SITE PLAN
SLIM CHICKENS
SVC OF S. PARKER ROAD AND E. PINE LANE, PARKER, CO 80134
SITE PLAN

C1.0

UTILITY PLAN

C3.0

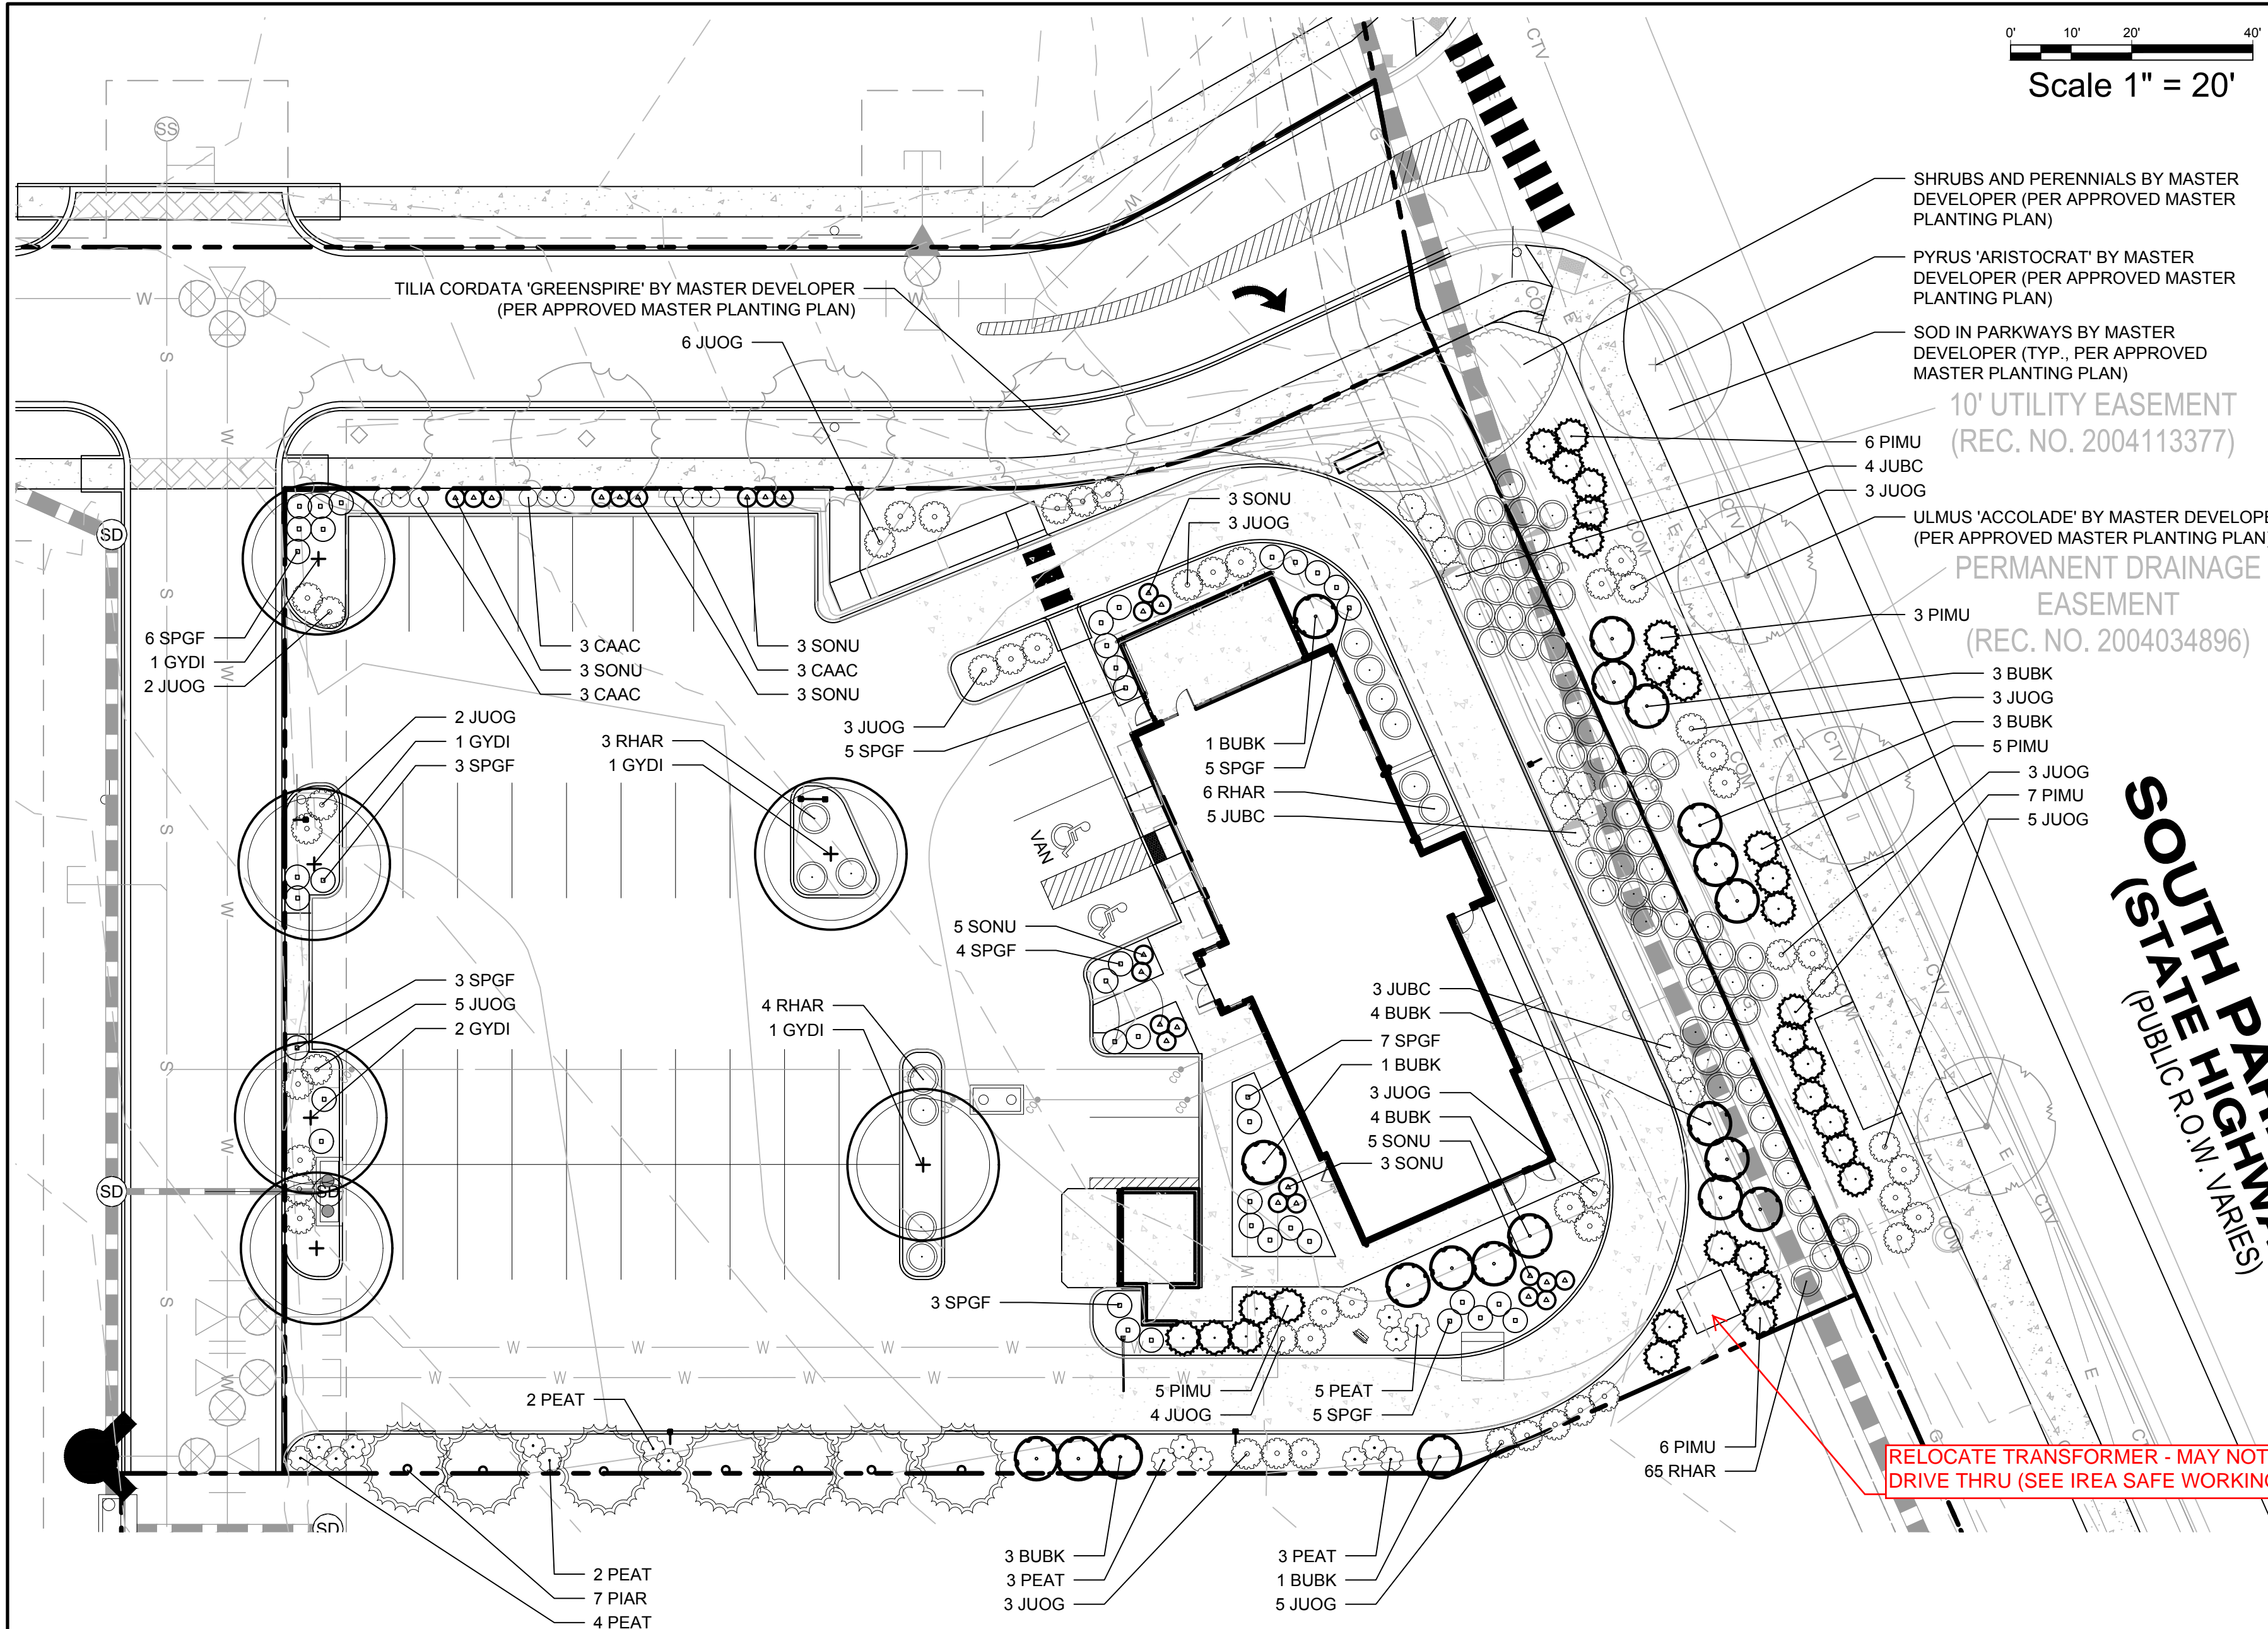
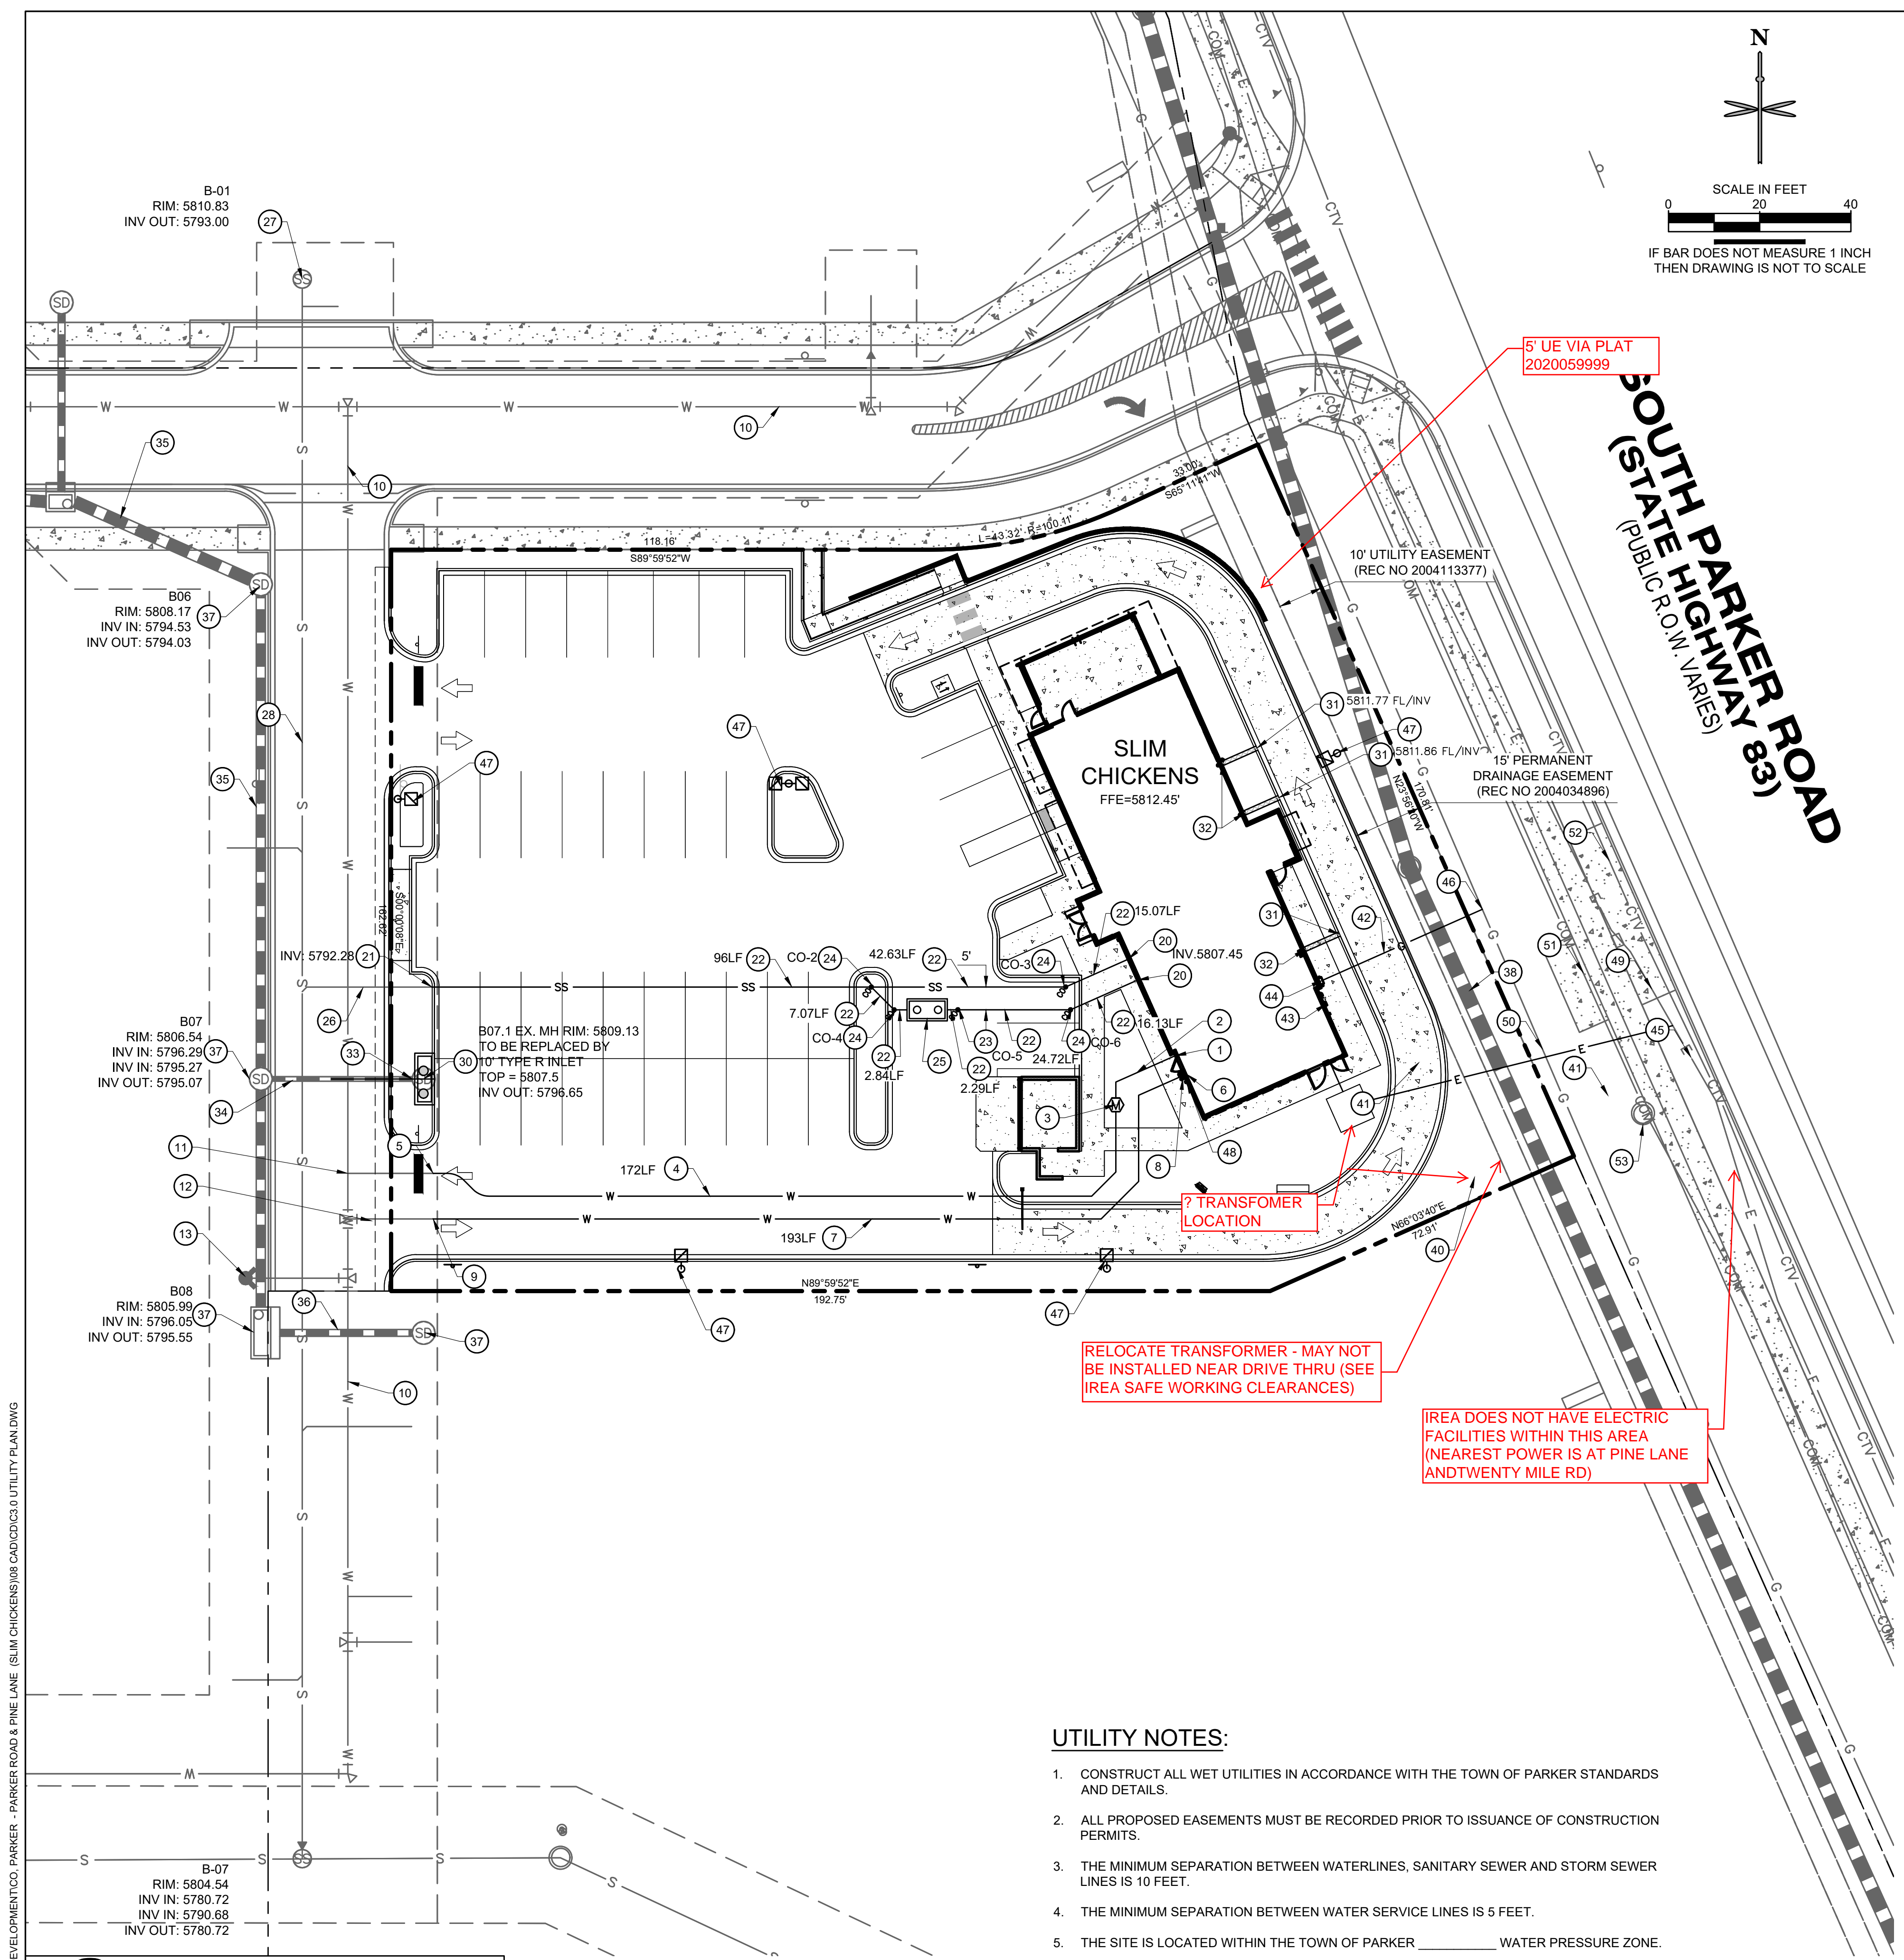
RELOCATE TRANSFORMER - MAY NOT BE INSTALLED NEAR DRIVE THRU (SEE IREA SAFE WORKING CLEARANCES)

AREA DOES NOT HAVE ELECTRIC FACILITIES WITHIN THIS AREA (NEAREST POWER IS AT PINE LANE AND TWENTY MILE RD)
